**Additions and Renovations to the Maurice Community Care Clinic
for Abbeville General Hospital
Maurice, Louisiana**

The Sellers Group
A Professional Corporation
Architects
Project No. 23023

Exhibit 'A' - Revised Riser P-10

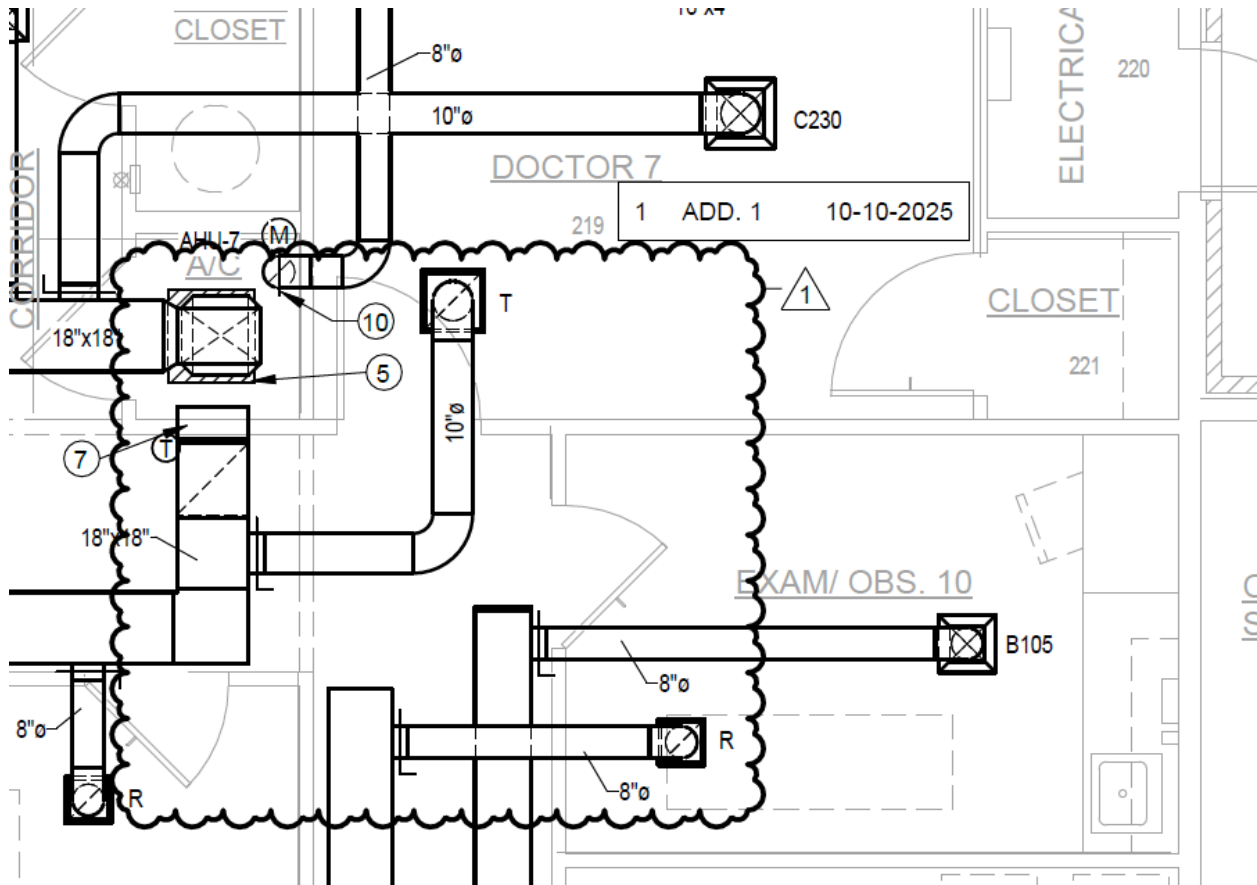
AD1.18: - Refer to Exhibit 'A' - Plumbing Riser Diagram P/10 which has portion (extra SK-A) removed and shall be revised as shown.

Plumbing Riser Diagram P/10 shall have portion removed to be revised as indicated
